**MOORE PUBLIC SCHOOLS -
WESTMOORE HIGH SCHOOL
ENTRY UPGRADES**

ADDENDUM NO. 1

May 20, 2026

Project Information

G101
INTERIOR PERSPECTIVE

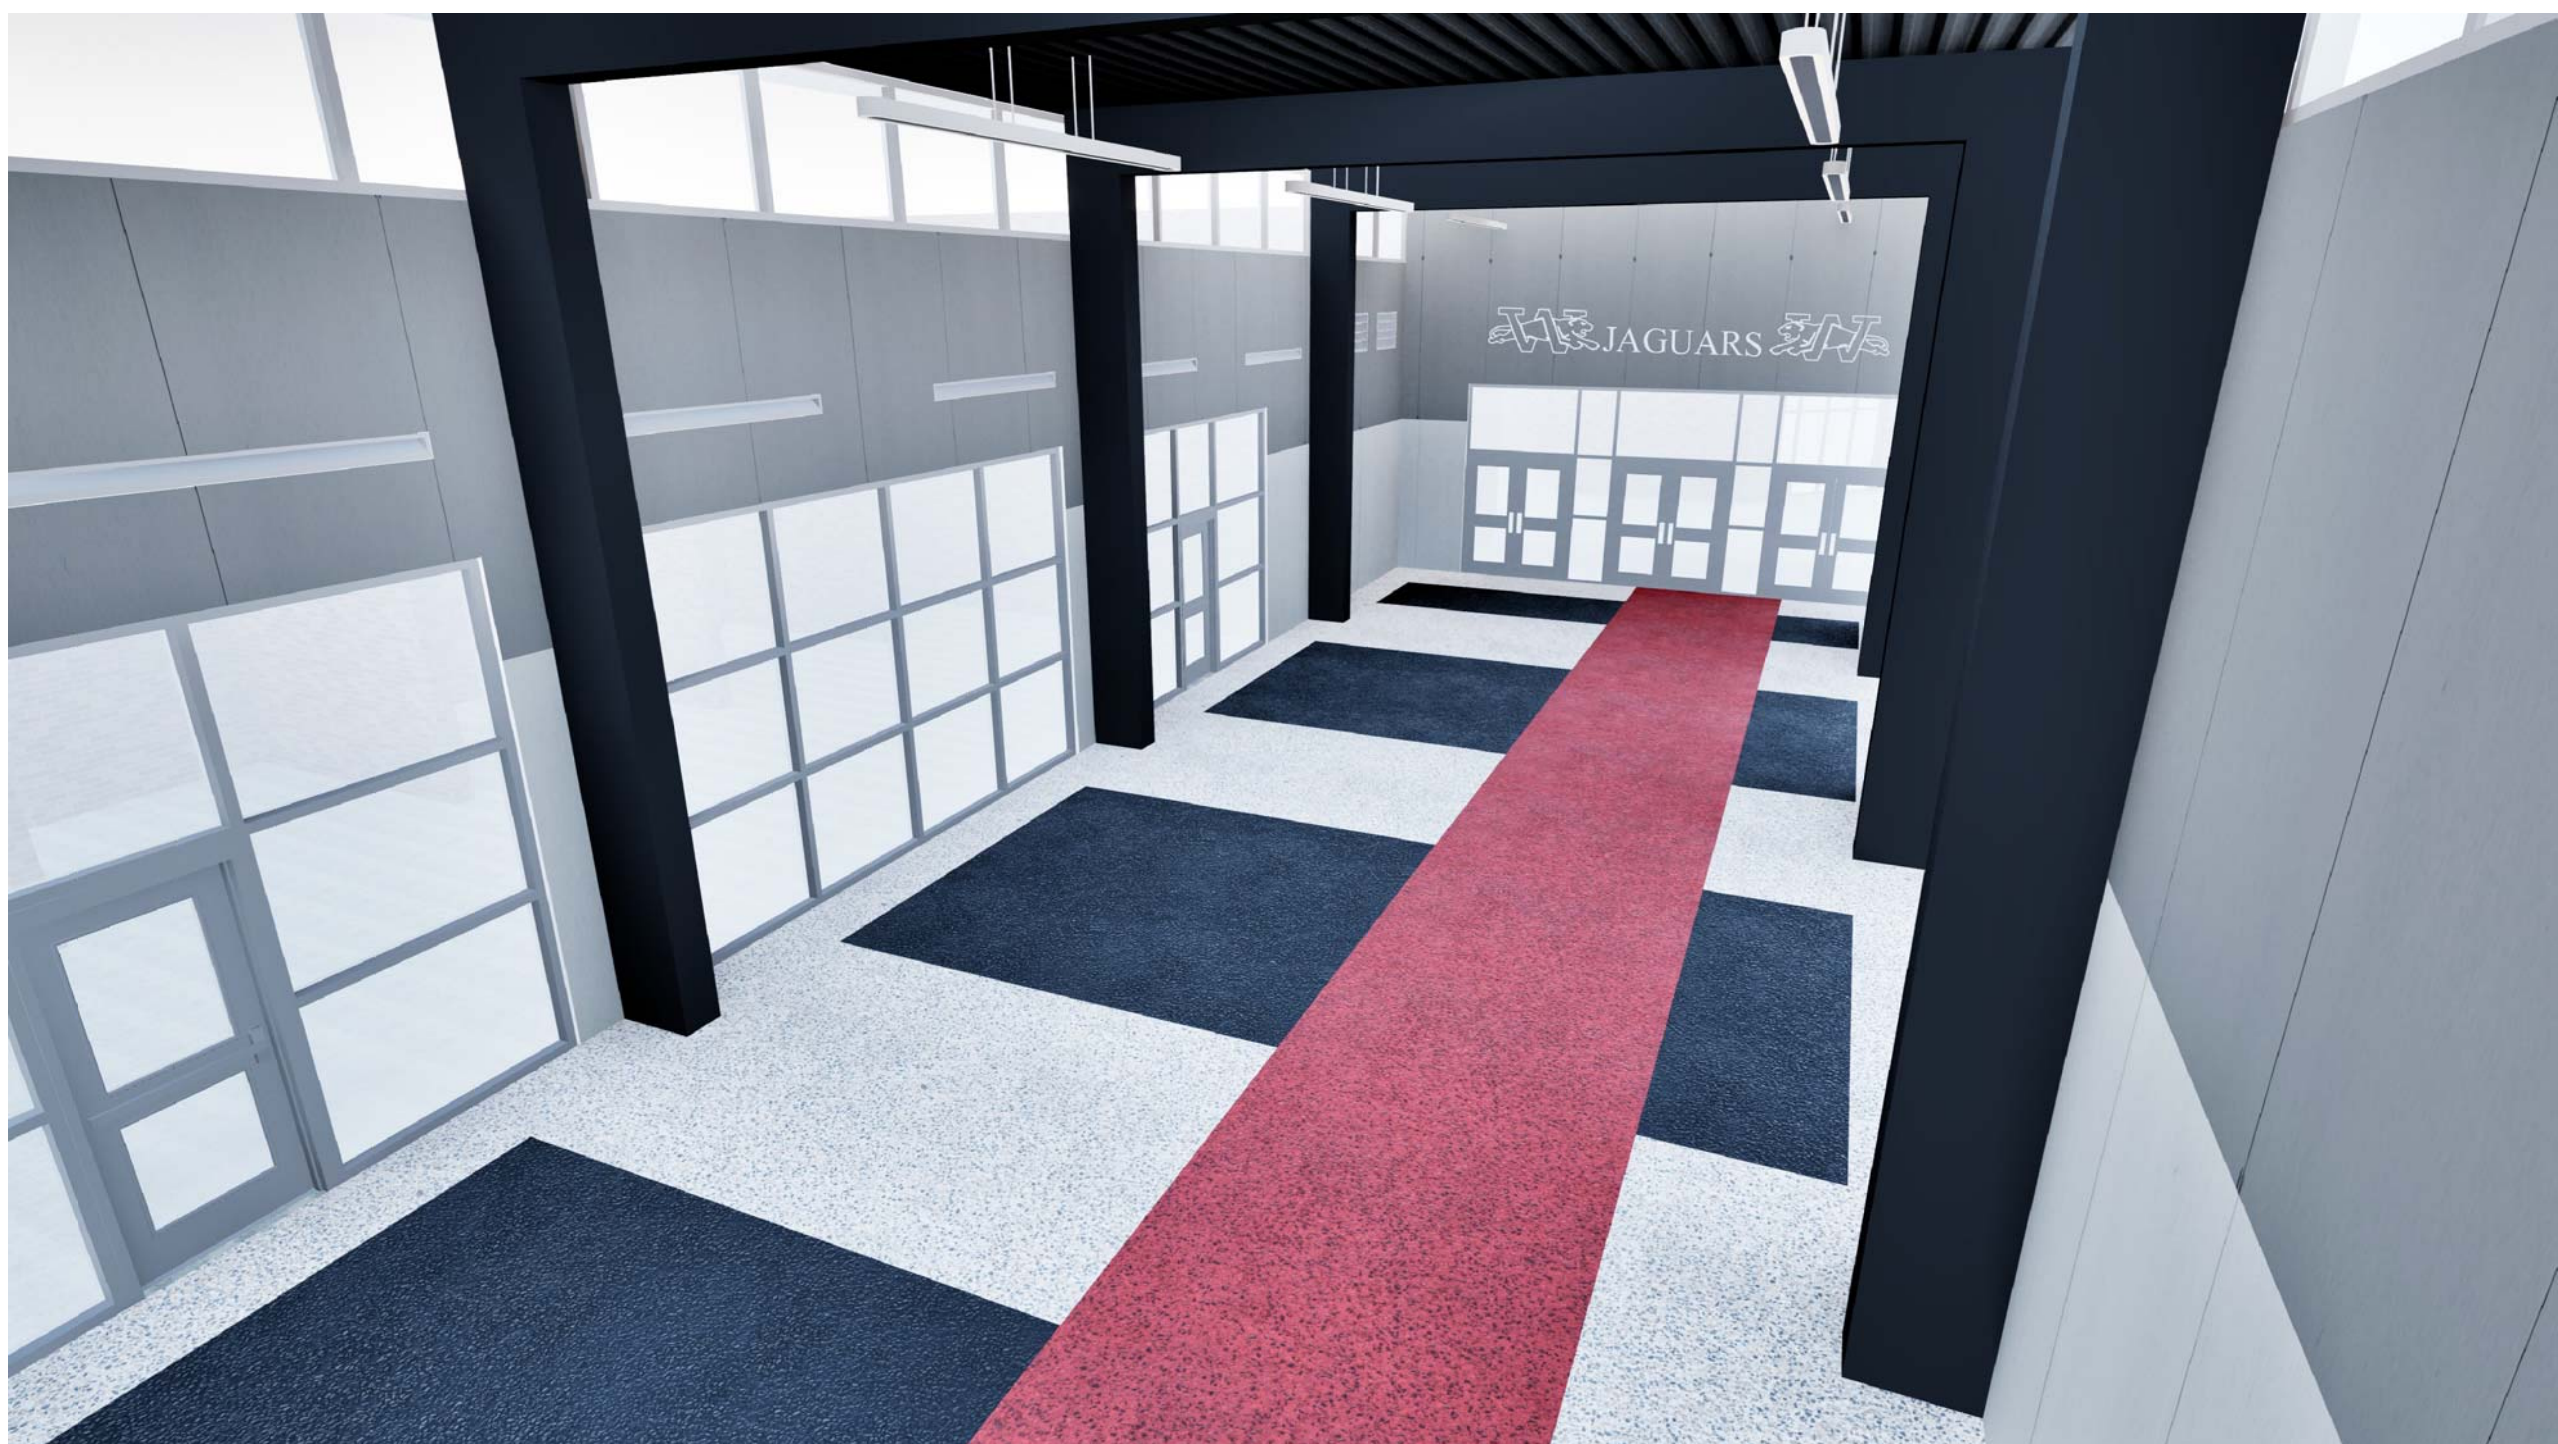
1. Sheet G101, Interior Perspectives: added sheet. Refer to attachment.
2. Sheet A104, Reflected Ceiling Plan / Notes: added notes / dimensions at Concourse Room #2, identified soffit material, and added Note No. 10. Refer to attachment.

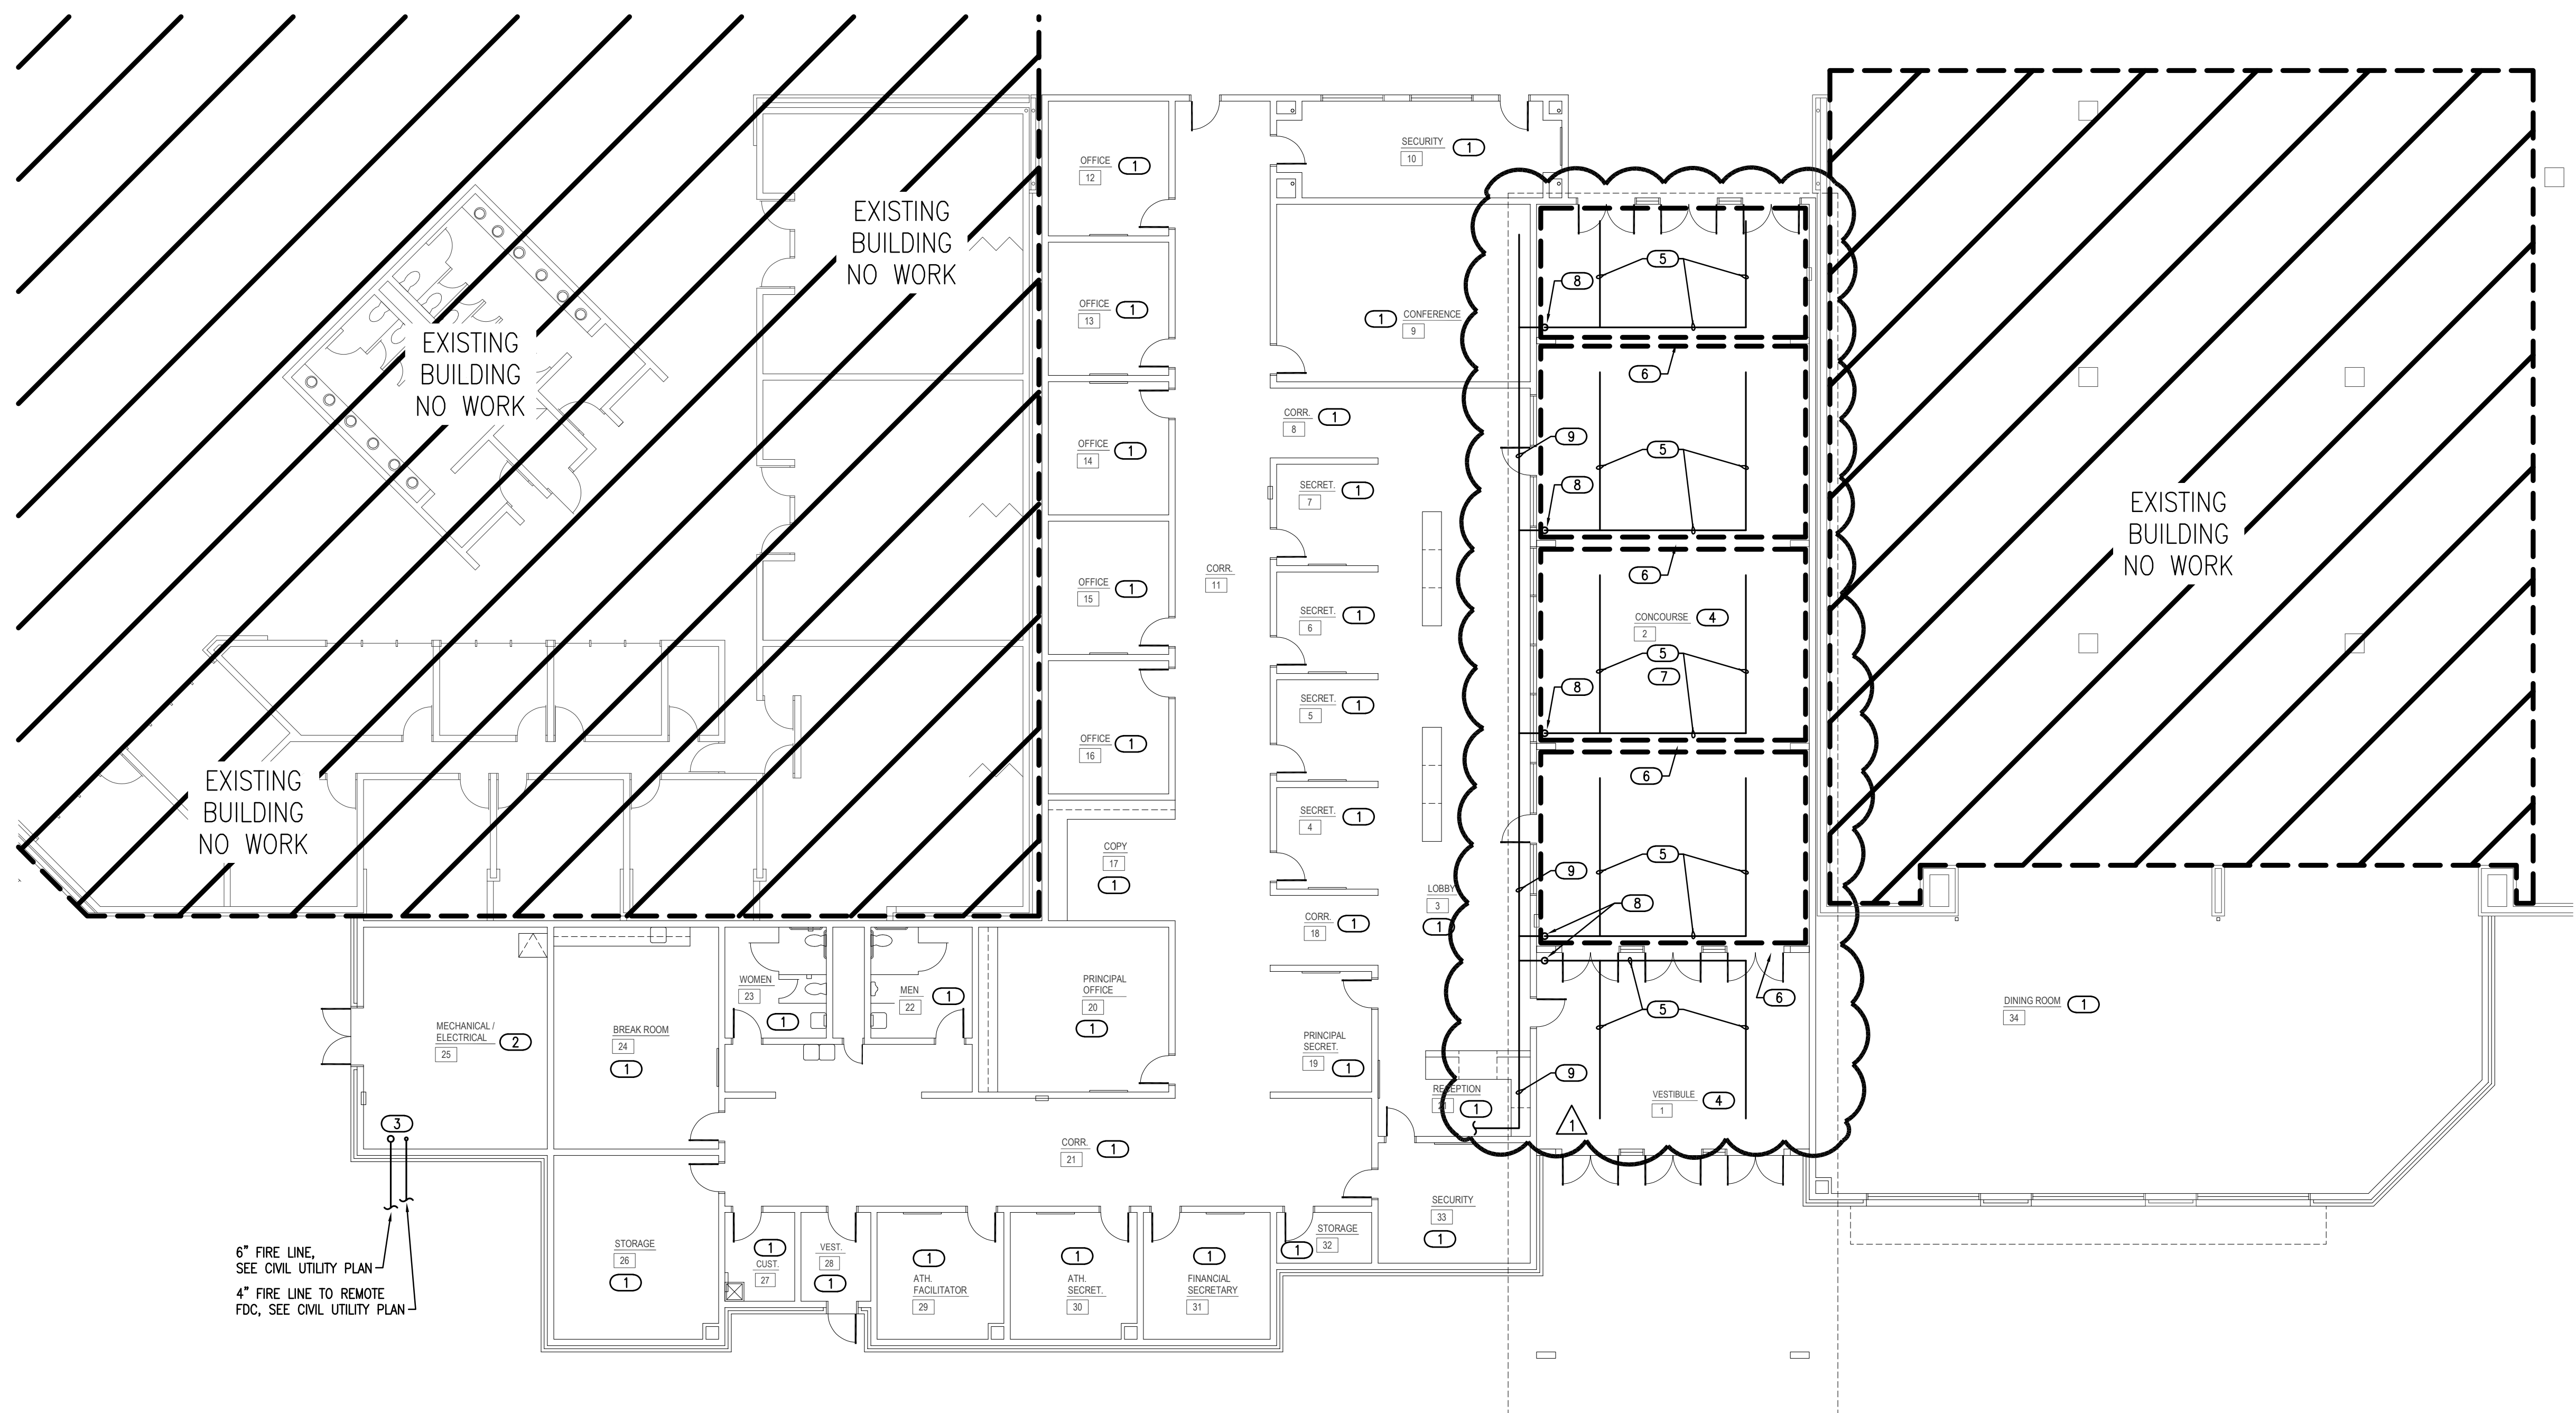
- ▲ F101 FIRE PROTECTION PLAN
 - Refer to clouds and deltas for changes on plans.
- ▲ E000 ELECTRICAL TITLE SHEET
 - Refer to clouds and deltas for changes on plans.
- ▲ E101 ELECTRICAL LIGHTING PLAN
 - Refer to clouds and deltas for changes on plans.
- ▲ E201 ELECTRICAL POWER PLAN
 - Refer to clouds and deltas for changes on plans.
- ▲ E601 ELECTRICAL SCHEDULES
 - Refer to clouds and deltas for changes on plans.
- ▲ T000 TECHNOLOGY NOTES AND LEGENDS
 - Refer to clouds and deltas for changes on plans.
- ▲ T201 TECHNOLOGY FLOOR PLAN
 - Refer to clouds and deltas for changes on plans.
- ▲ M101 MECHANICAL FLOOR PLAN
 - Refer to clouds and deltas for changes on plans.
- ▲ M501 MECHANICAL DETAILS
 - Refer to clouds and deltas for changes on plans.
